This guide answers questions about the [supplemental storm detention requirements](#) in Chapter 9 of the Infrastructure Design Manual (IDM). The new requirements go into effect on March 31, 2021.

STORM DETENTION REQUIREMENTS FREQUENTLY ASKED QUESTIONS

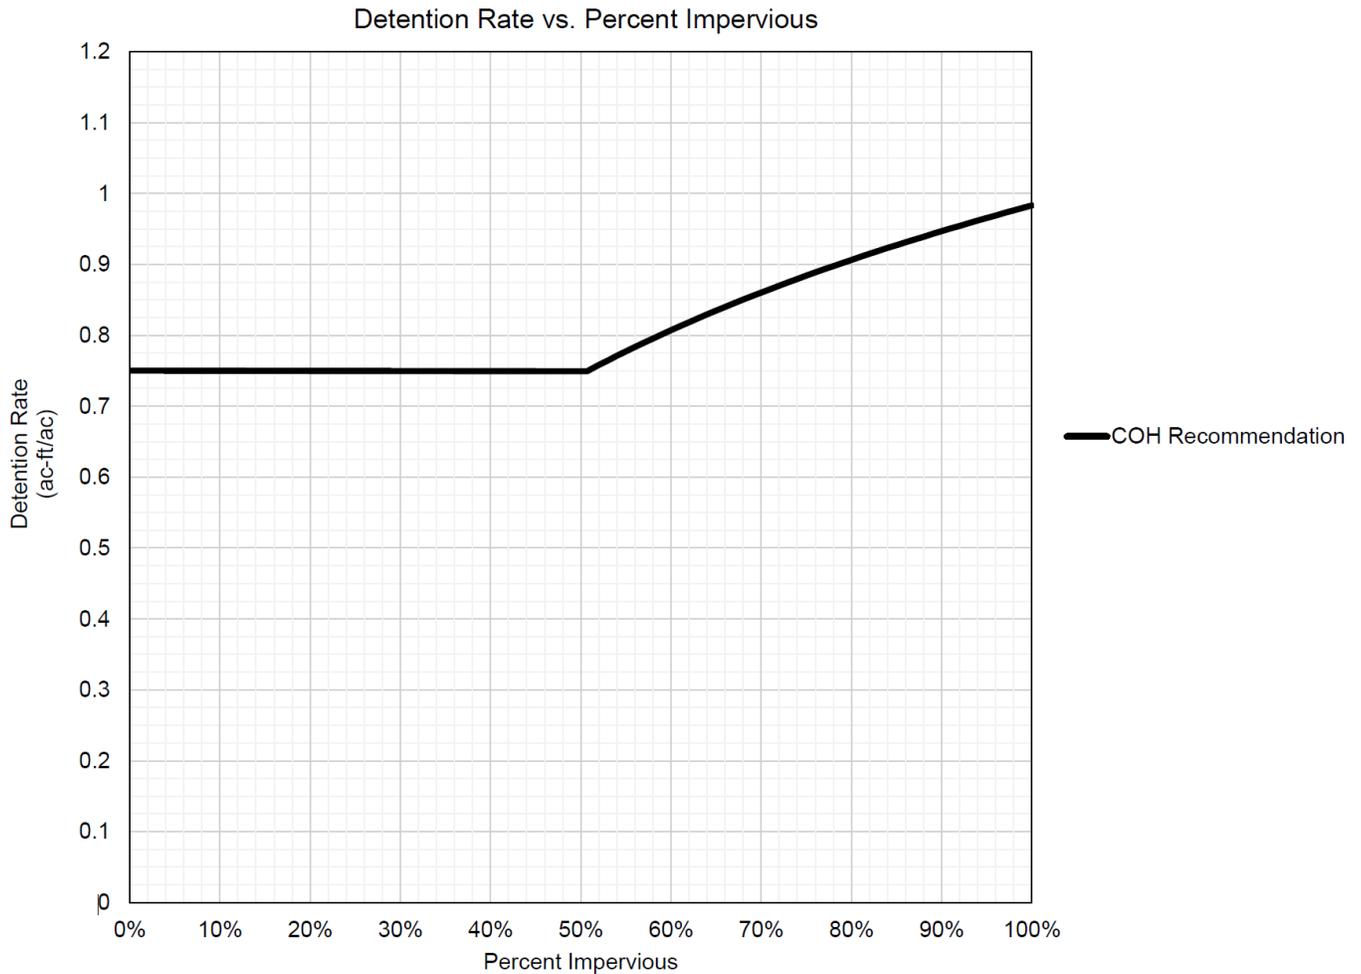
Can the Detention Rate vs. Percent Impervious graph also be provided in a tabular or equation form? Above 50% impervious, the detention recommendation line appears to be a curve, not a line.

Yes, a table and larger version of curve is provided below.

Proposed Percent Impervious	Minimum Detention Rate acre-foot/acre
0% - 51%	0.75
55%	0.78
60%	0.81
65%	0.83
70%	0.86
75%	0.88
80%	0.91
85%	0.93
90%	0.95
95%	0.97
100%	0.98
